Docket Number:	15-AAER-02
Project Title:	Pool Pumps and Spa Labeling
TN #:	210559
Document Title:	California Investor Owned Utilities Comments: CA IOUs Response to Draft Title 20 Regulations_Pool Pump Motors & Portable Electric Spas 2-29-2016
Description:	N/A
Filer:	System
Organization:	California Investor Owned Utilities
Submitter Role:	Public
Submission Date:	2/29/2016 4:44:44 PM
Docketed Date:	2/29/2016

Comments regarding draft regulations:
Pool pump motors & portable electric spas

Docket # 15-AAER-02

February 29th, 2016

Figure 4: Proposed Label for Portable Electric Spas

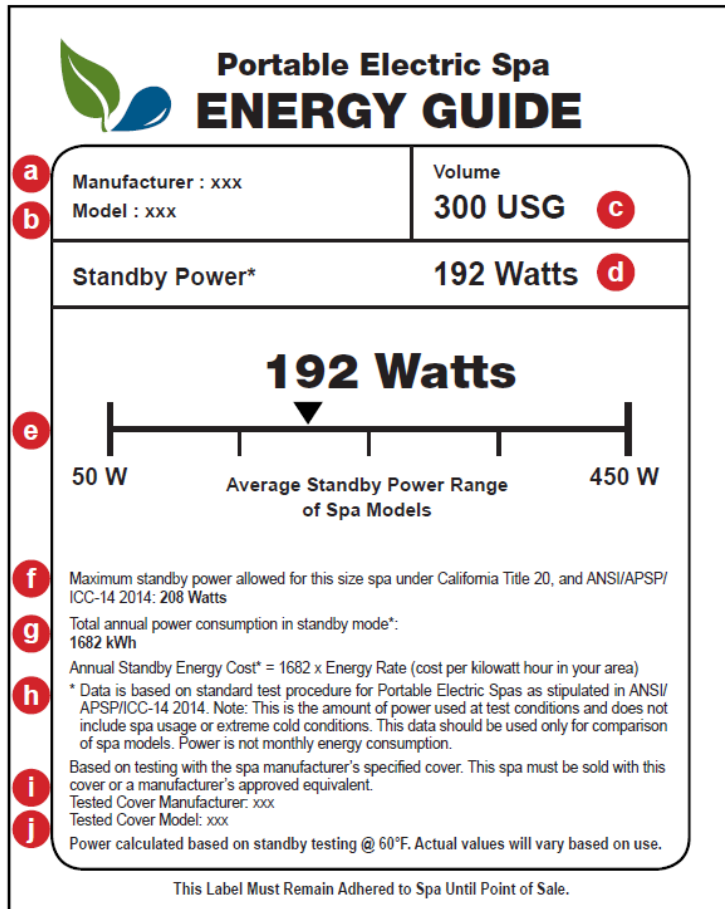
The CA IOUs broadly support the labeling scheme CEC staff has proposed (seen below in Figure 4) which reflects the work between the CA IOUs and the APSP-14 committee in the spring of 2014. This label design was also recommended as part of the CASE report the CA IOUs submitted to CEC on May 15th, 2014, and in the publication of the APSP-14-2014 voluntary standard. We believe this label will provide valuable information to consumers and also lead to more energy efficient purchasing decisions. However, we also recommend CEC propose a second label for

exercise/combination spas which adjusts the upper (450 W) and lower (50 W) power ratings to account for these larger products. Doing so should be fairly easy as no other changes would need to be made to the label.

Nevertheless, we recommend that the language on spa covers (See “i” in above label) be changed to indicate that only the cover for which the spa was tested with can be sold with the spa. A spa with a different cover is an entirely different product as it will perform differently. Allowing manufacturers to sell spas in California with a cover other than with the cover that they tested with and certified to CEC would be misrepresenting the performance of the product and not be in compliance with Title 20 regulations. We propose that if a manufacturer wants to sell the same spa with a different cover, then they should test the spa separately with each cover and submit them as two separate products in CEC’s database. Accordingly, we propose that the language on the label be modified to reflect that only the spa cover for which the spa was tested with can be sold with the spa.

Additionally, in order to verify that the proper spa cover is being sold with the spa, we propose that all spa covers sold with new portable electric spas be marked with the manufacturer’s name and model number. This way a customer (and CEC) can see that the cover being sold with the spa matches the cover listed on the label and will perform as the label claims.

Recommendation: The CA IOUs encourage CEC to specify a separate label for exercise and combination spas with different lower and upper limits for standby watts since these products use significantly more than the current upper limit of 450 standby watts.

Recommendation: The CA IOUs propose the portable electric spa label (as shown in Figure 4) be modified to reflect that only the spa cover for which the spa was tested with can be sold with the spa.

Based on testing with the spa manufacturer's specified cover. This spa must be sold with ~~the~~ this cover listed below of a manufacturer's approved equivalent:

~~Tested~~ Cover Manufacturer: xxx

~~Tested~~ Cover Model: xxx
